Item ID: D350-607-541 Accept *N9000040100* Setup Start *NS1*
 Revision ID: Stop *NS2*
 Item Name: Quick Release Heli-Utility-Basket™ Long, HD Lid, Spacepod™/Squirrel Cheek Comp.
 Start Date: 10/2/2015 Start Qty: 1.00 *1* Cust Item ID:
 Required Date: 10/14/2015 Req'd Qty: 1.00 *1* Customer:
 Reference:

DART SERVICE INSTRUCTION

TO AMEND INSTALLATION INSTRUCTIONS D350-607-3 Rev.D,
INSTALLATION INSTRUCTIONS D350-607-4 Rev. C AND
INSTRUCTIONS FOR CONTINUED AIRWORTHINESS ICA-D350-607 REV. 6
REF TCCA STC: SH94-14
REF FAA STC: SR00213NY
REF EASA STC: EASA.10016996
REF BRAZILIAN STC: 2007S03-03/-04/-05/-06

FIGURE 1: INSTALLATION OF D4775-041 FWD STRUT

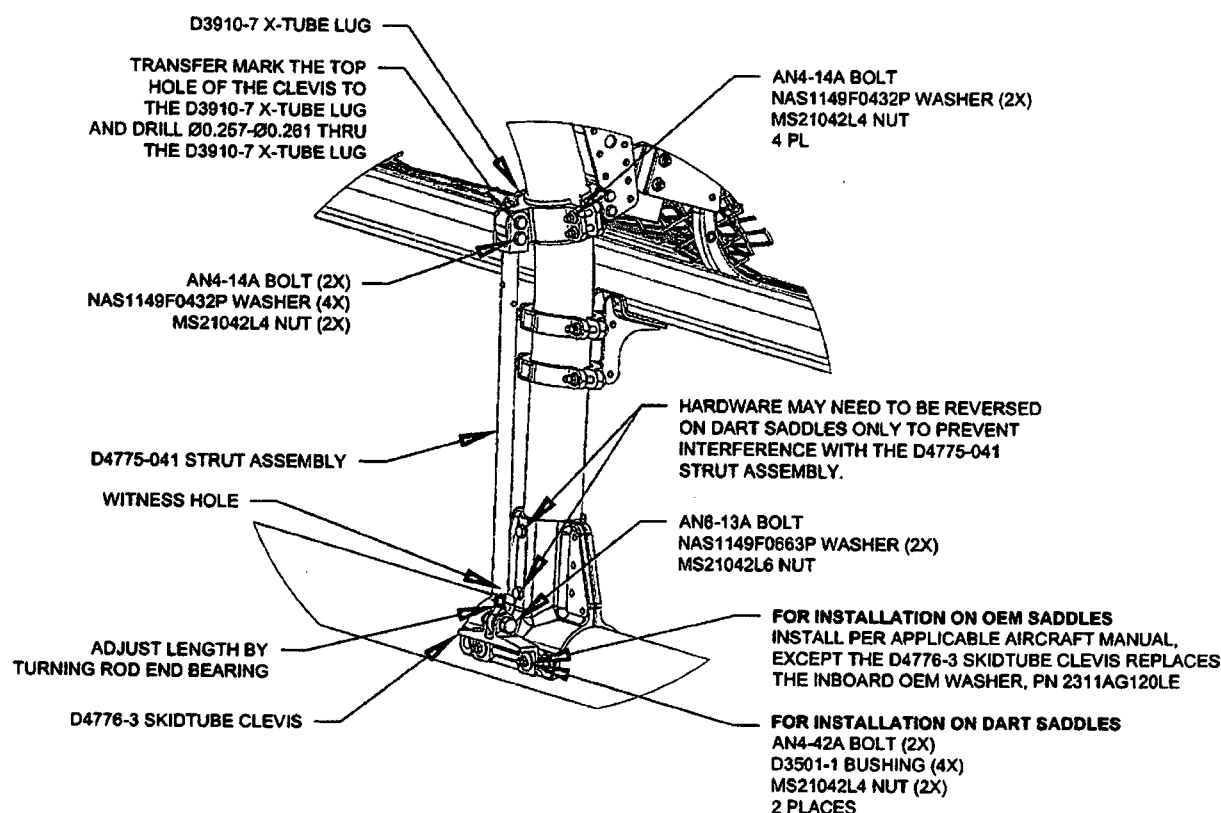
- 3.1 Substitute the Forward Lower D3910-5 X-Tube Lug with the D3910-7 X-Tube Lug as shown in Figure 1.
- 3.2 Install the forward D4775-041 Strut Assembly. Transfer mark from the upper hole on the clevis of the D4775-041 Strut Assembly to the D3910-7 X-tube Lug and drill thru the lug $\varnothing 0.257$ - $\varnothing 0.261$ as shown in Figure 1. Touch up chemical conversion coating per MIL-DTL-5541. Check the witness holes located at the bottom end of the D4775-041 Strut Assemblies to ensure that the thread from the rod end extends past the witness hole.
Torque MS21042L4/-4 nuts to 50-70 in-lbs (5.7-7.9 N-m). Torque MS21042L6/-6 nuts to 160-190 in-lbs (18.1-21.5 N-m).
- 3.3 Complete the installation in accordance with Installation Instructions D350-607-3 Rev. D or D350-607-4 Rev. C.
